COUNCIL ACTION FORM

REQUEST: **AMENDMENT TO INTEGRATED SITE PLAN SUBDIVISION FOR 1409 AND 1419 BUCKEYE AVENUE INCLUDING FIFTH ADDITION TO SOUTHWOOD SUBDIVISION MAJOR SITE DEVELOPMENT PLAN.**

2018 Major Site Plan – Building B

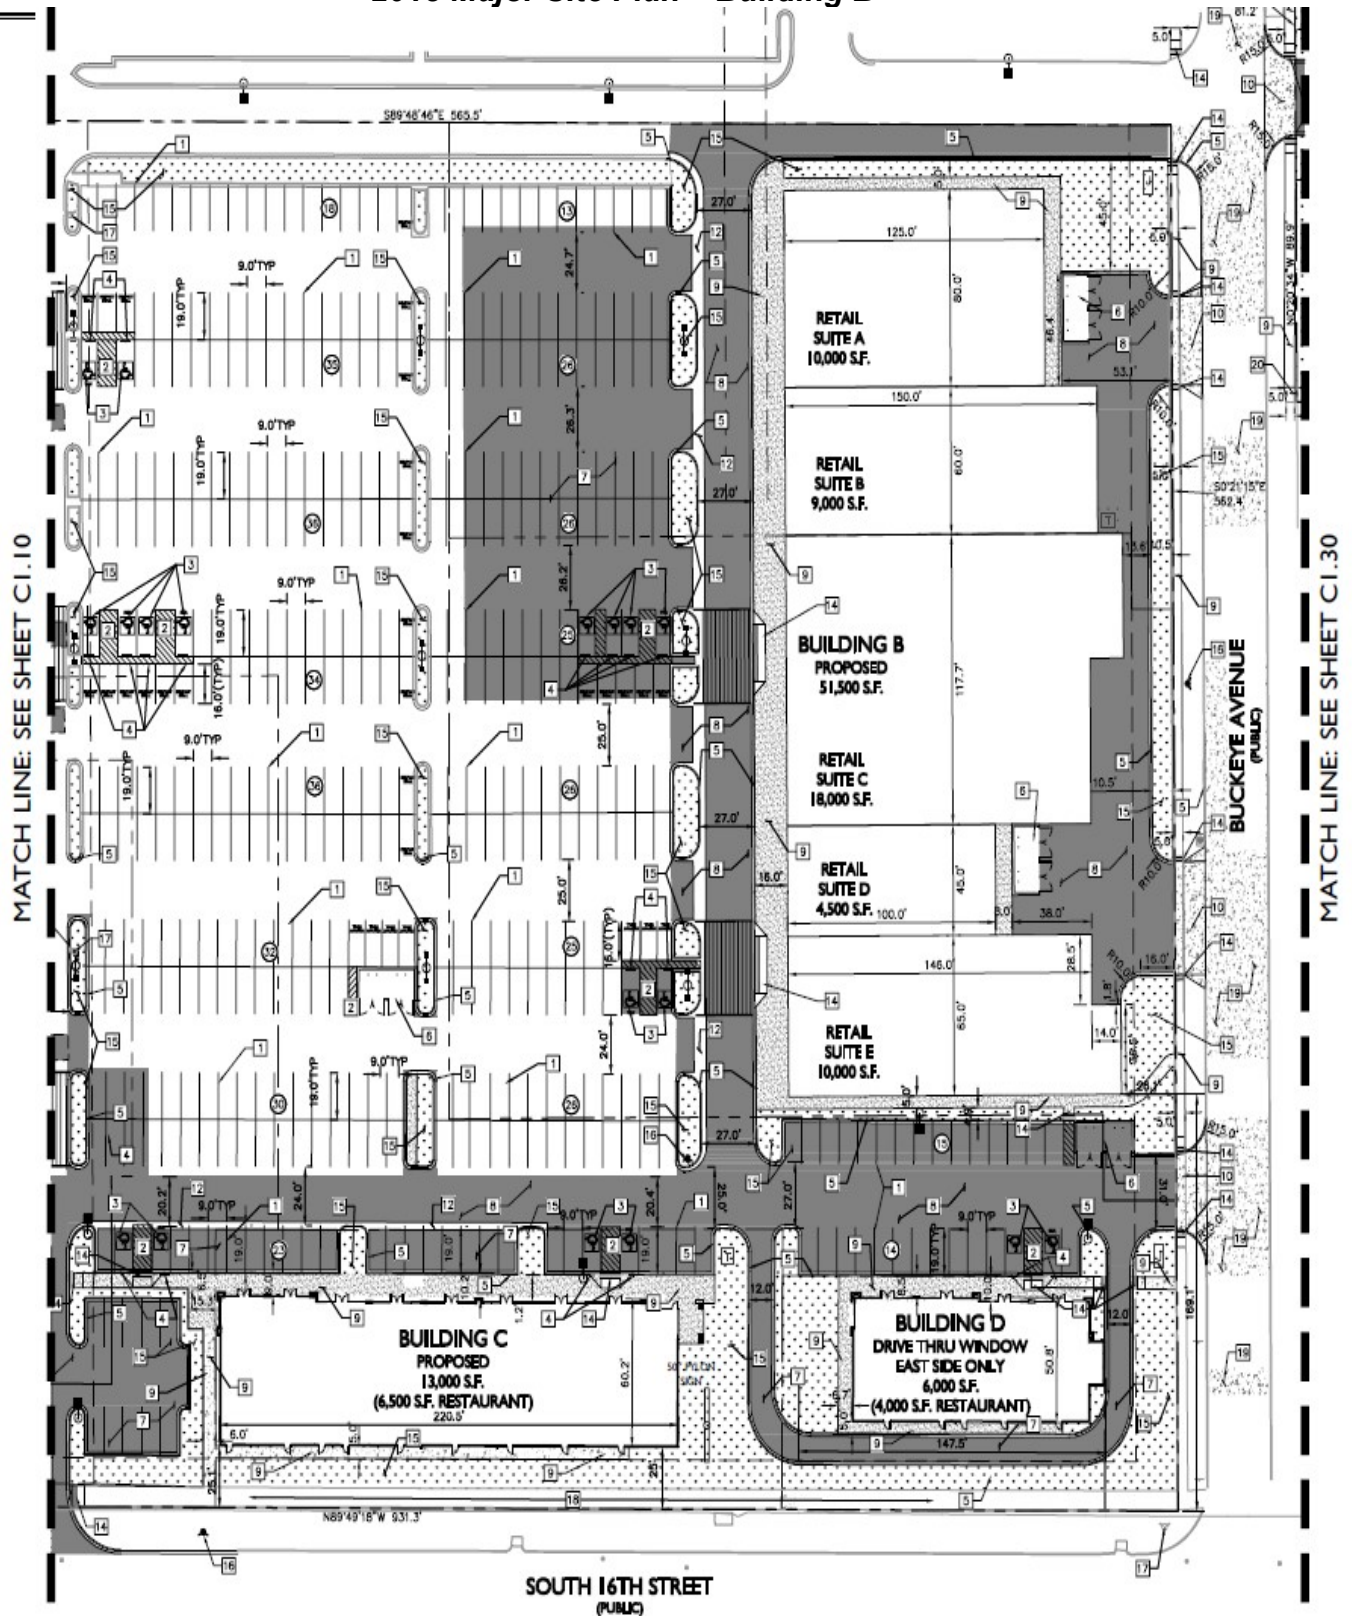
The original Plan includes loading areas in the rear along Buckeye (Attachment B – 2018 Site Plan). Loading areas remain in the rear along Buckeye but have been reconfigured to have one large loading area at the southeast corner with access from Buckeye and a second loading area at the northeast accessed off of the shopping center driveway. The two loading areas are no longer interconnected and this results in additional yard area for landscaping in the middle of the block. The southeast loading area is more prominent than the original approval due to its new orientation to serve the reconfigured building. Loading areas must be designed for the functional needs of tenants and access limitations of the City to public streets. The City's traffic engineer has determined the configuration meets minimum standards for driveway spacing and limitations on driveway width.

2021 Major Site Plan

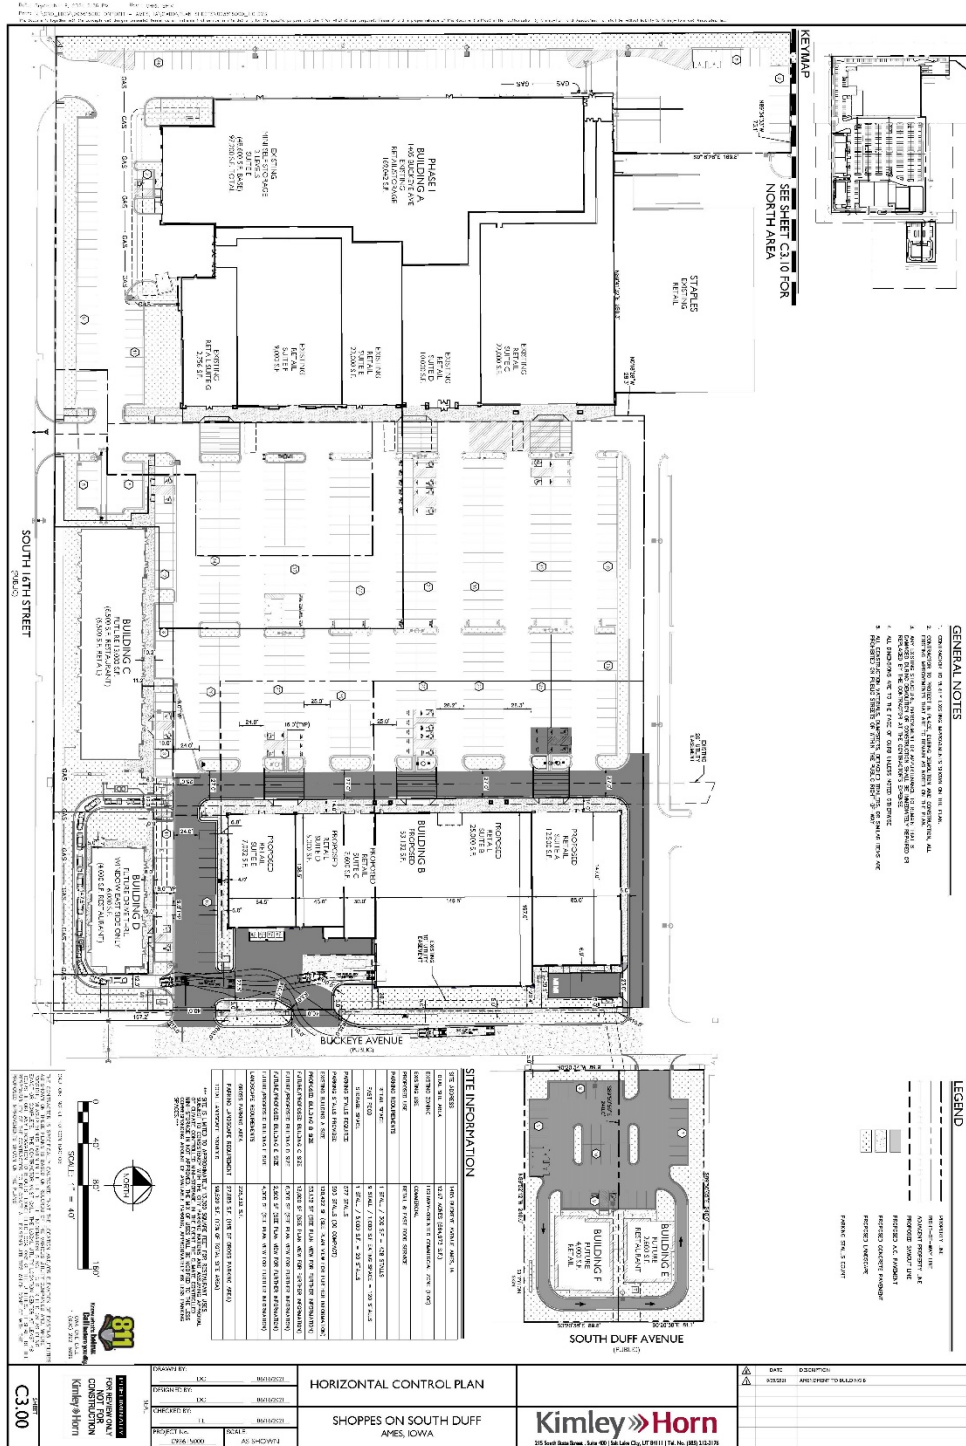
This Amendment includes a 53,132 square foot building, divided into five tenant spaces. This is an increase of 1,632 square feet from the 2018 plan. Five tenant spaces is consistent with the 2018 plan. There are no proposed changes to any of the other buildings shown on the existing approved Site Plan.

The proposed parking plan includes fifteen (15) new stalls to be constructed at the south end of Building B as was shown in the 2018 plan. This plan shows the retention of existing parking areas and the construction of new parking areas the same as was shown in 2018.

Pedestrian connectivity is improved with this amendment between Building B and proposed future buildings. Sidewalks are now shown in front of all buildings with ramps and crossings of drives between buildings. Additionally, a new sidewalk provides a connection to Buckeye Avenue on the north side of the building, adjacent to an existing CyRide stop on Buckeye.

A-203
ELEVATIONS
10/10/17

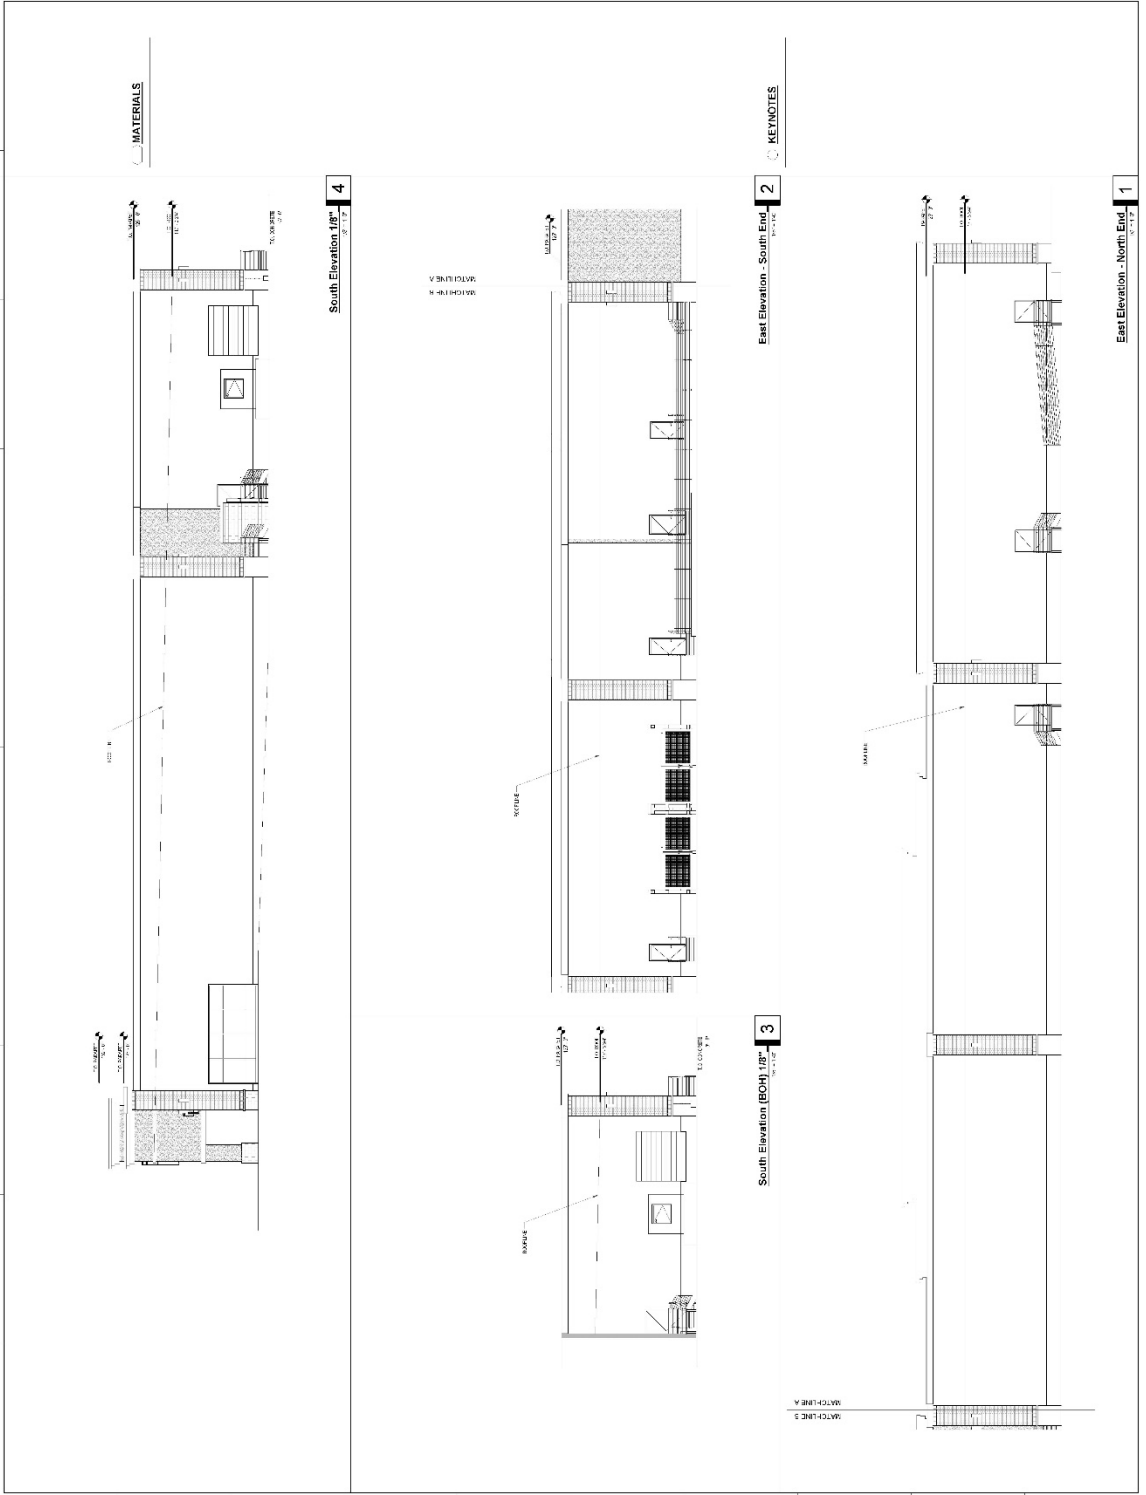
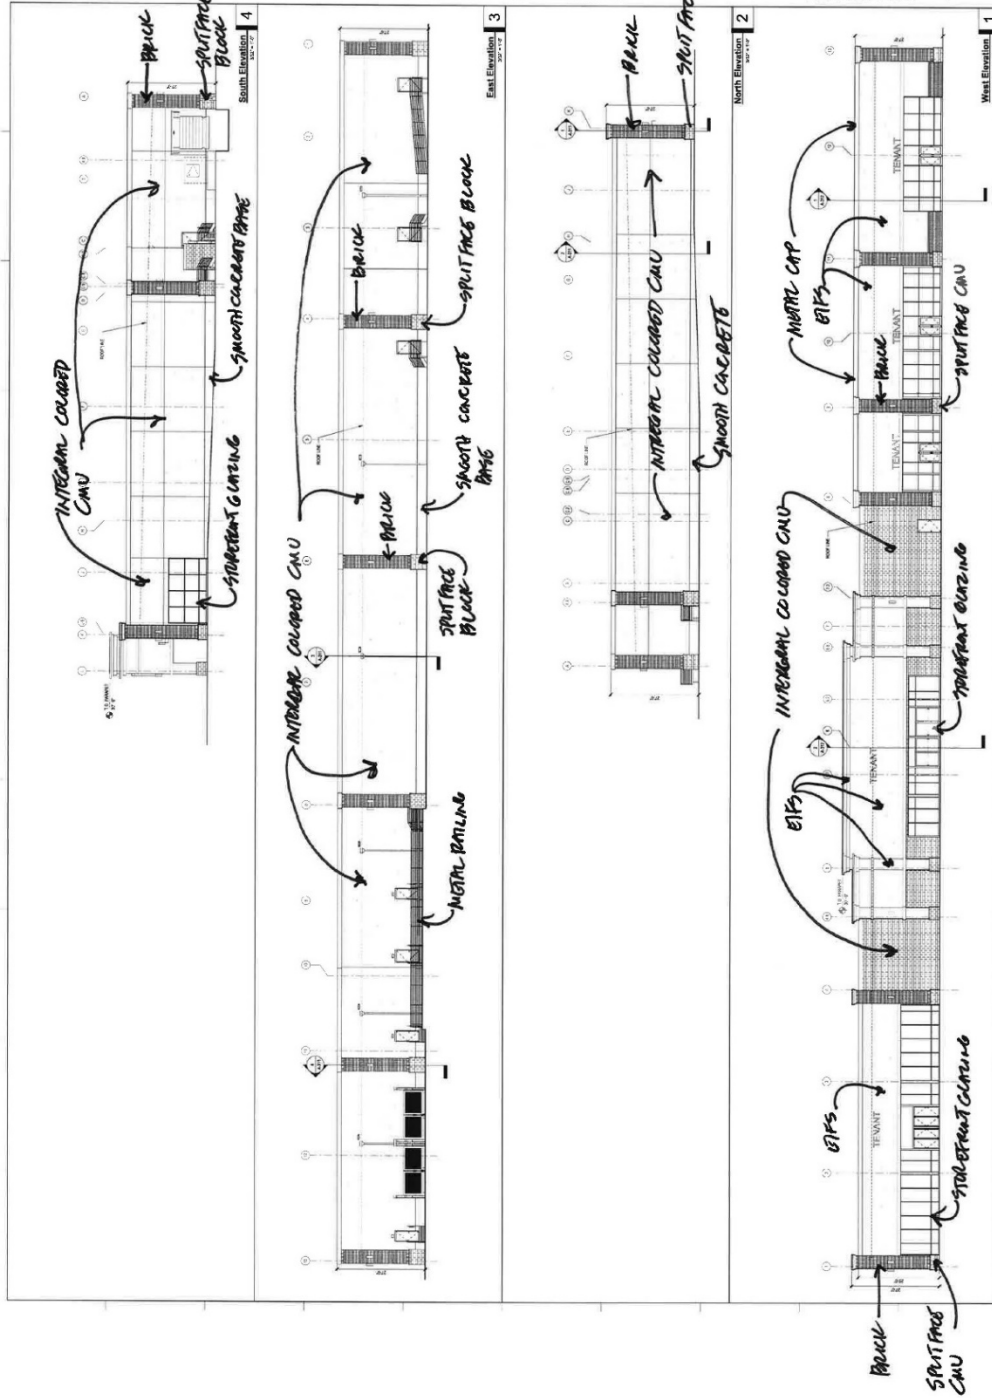
The rear elevations of the building along Buckeye have no proposed roof line variation or detailing other than a cornice and an occasional brick pilaster. The buildings are located

as close as 25 feet from the street property lines. The facades of Building B have modulation due to differences in tenant space sizing and planned loading areas. Brick pilasters have been added to the sides and rear of the building to break up the façade and provide some visual interest as opposed to long blank walls.

The building elevations do indicate some lighting will be located on the buildings. The drawings give the appearance that the lights may be up lit and not meet dark sky requirements. This is not allowed by code if lights are over a certain amount of lumens. Fixture information was not provided for such lighting. It should be noted that all site lighting on buildings and in parking areas will need to comply with the City's Outdoor Lighting Code.

All lighting will be required to comply with the City's Outdoor Lighting code, Section 29.411. Building lighting must also meet downlighting requirements.
